## Product Change Notification

**PCN Number: 1008-00**

**Title:** Heatsink GE Infusion Wire Routing Modification

**PCN Publish Date:** January 27, 2012

Figure 1. Image of the Twist Module Cooler 43W Heatsink showing the new wire routing slot in the face of the Heatsink.

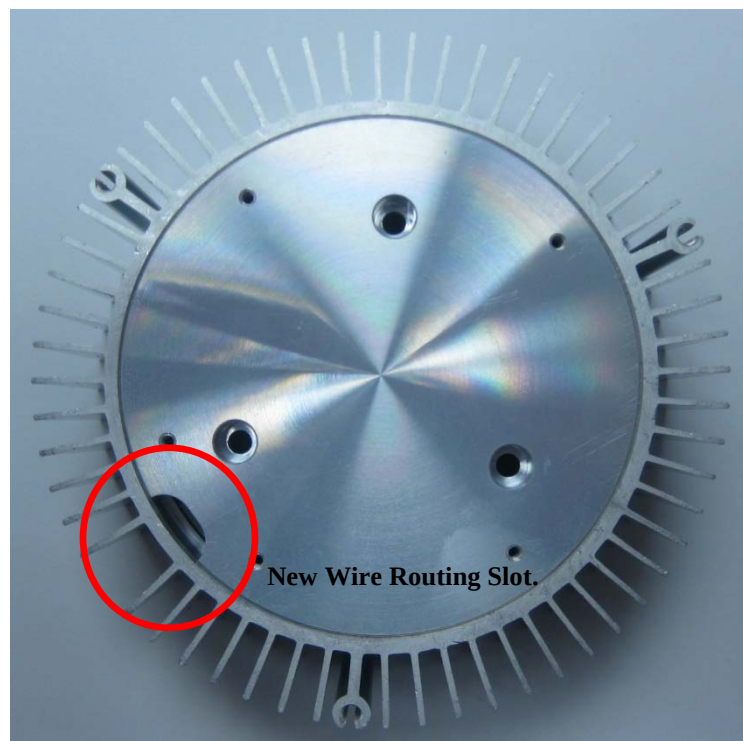
A wire routing slot has been added to the Twist Module Cooler 43W Heatsink. This Heatsink is the primary Heatsink for the GE Infusion Module. The new slot allows the wires of the GE Infusion Module to be routed through the face of the Heatsink.

The part numbers in the table below have been modified to include this new wire routing slot. All future production of these two part numbers will have this change incorporated. This revision is being implemented as a running change. All existing inventory will be used.
